TO: IPC

Purpose: Submission on Additional Material

SUBMITTER: OWNER OF 803/50 Murray Street Pyrmont

Extract of open space under the new proposal addressing accessibility and contiguous issues

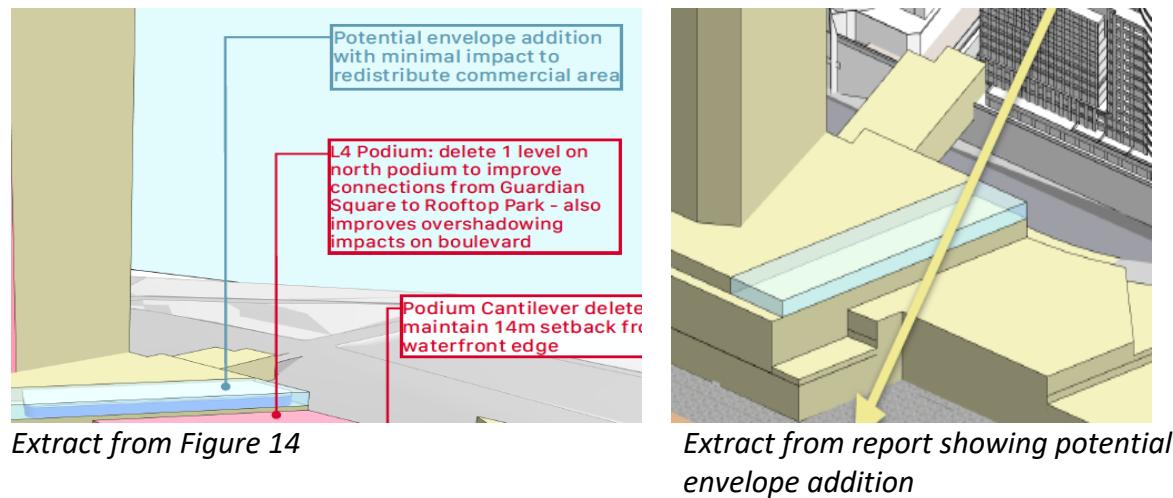
There is question mark as to what exactly is the option as it relates to the RLs of the northern podium.

Figure 14 of the Ethos Urban Report has a reference box stating “Potential envelope addition with minimal impact to redistribute commercial area”. This would mean increasing RL 26.5 to RL 31.0. This is not mentioned anywhere else in the report although it is shaded in light blue in other Figures.

No mention of increasing the northern podium from RL 26.5 to RL 31.0.

At 5.0 the only adjustment to the northern podium referenced is the lowering of RL 25 to RL31.0. The diagram below does not mention any redistribution to increase the RL265. To RL31.0.

Notwithstanding the clarity around the exact proposal, we would object if it was intended that the RL26.5 would be increased as it would add to the bulk and scale around the tower, further overshadow the public domain and further add to the loss of views of One Darling Harbour.

Comment on lowering the RL 25.0 to RL21.35

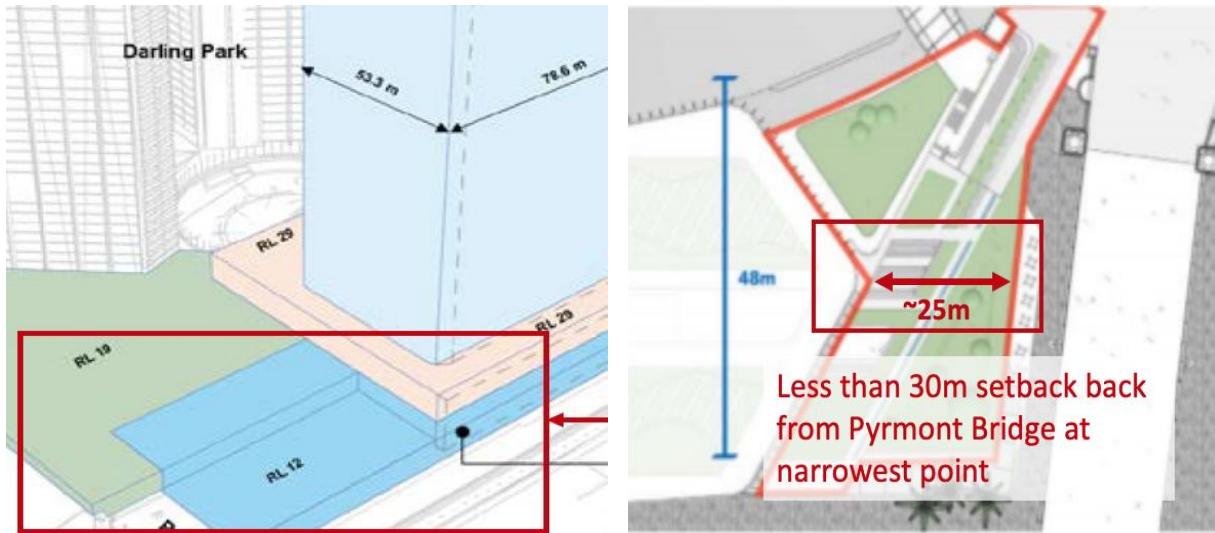
The RL 25 to RL 21.35 is the only change to the height of the northern podium. I welcome the recognition that the height of the northern podium is far too high.

Notwithstanding the removal of the overhang to foreshore, the new proposal for the northern podium still unreasonably impacts on the surrounding area, particularly the public domain at the foreshore and the heritage Pyrmont Bridge, and is not commensurate in bulk and scale with neighbouring Cockle Bay redevelopment providing two inconsistent character of addressing the Cockle Bay basin.

In contrast, the Harbourside Shopping Centre Redevelopment new proposal has a podium starting at RL of 13.75 and extends only some **30m** from Pyrmont Bridge before, under the new proposal, proposing to rise to **RL 21.35**, which is still close to **twice** the height of the Bridge **RL11.8**.

Further the proposed envelope does not include lift overrun (which Councils insist on) nor the height of landscaping or amenities which will further add to the bulk and scale of the northern podium. The envelope should include all landscaping and lift overruns.

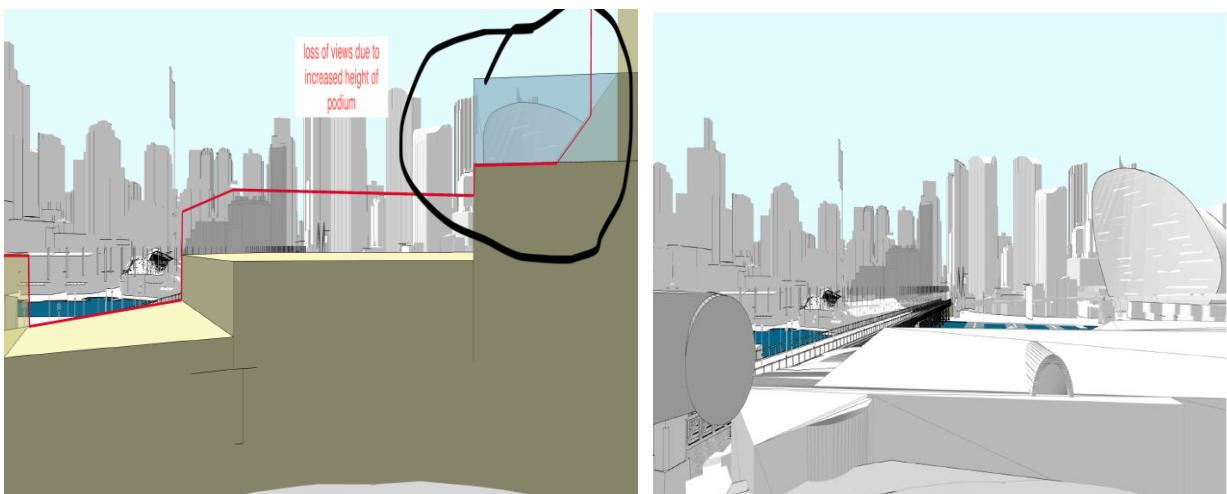
First let me point out again that the ‘Potential envelop addition’ has been included in the diagram and shows clearly that there would be **further significant loss** of views (almost total in some case) of the CBD and highly valued water view sin the case of Unit 504 and removes the relief offered by reducing the RL from 25.0 to 21.35.

If the ‘Potential envelop addition’ is not to be included the units on level get some relief of seeing the less valued view of the CBD but unto 504 still gets on relief of the highly valued water views

Unit 201: View sharing under new proposal

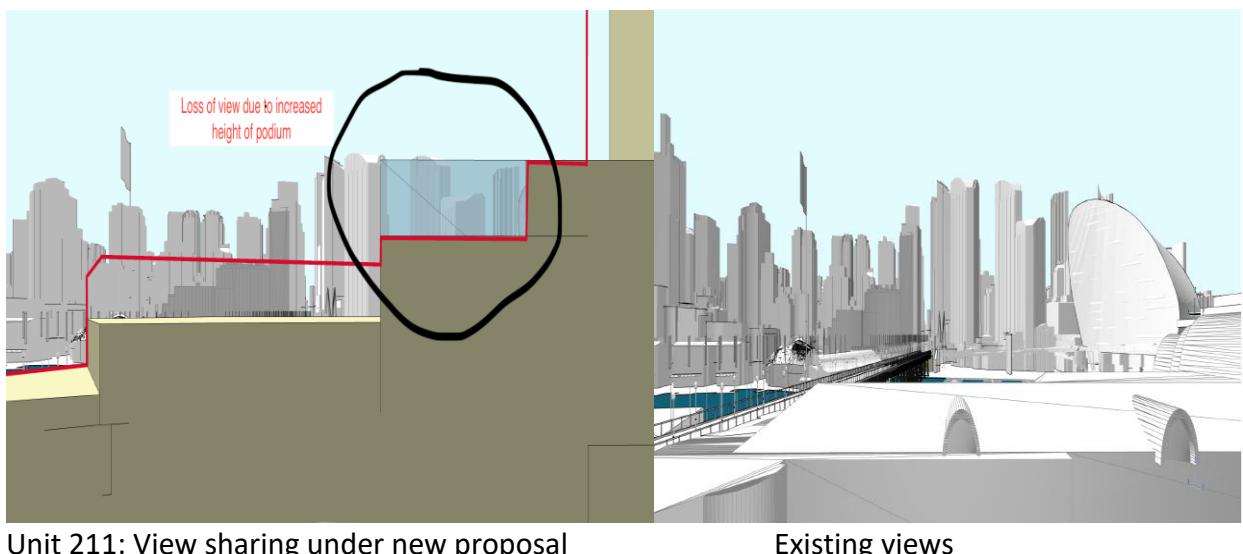
Notwithstanding some relief it should be pointed out that the views from Units 201 and 204 and to lesser extent unit 504, will be replaced by what looks more like a car park façade rather than high quality design claimed both by the applicant.
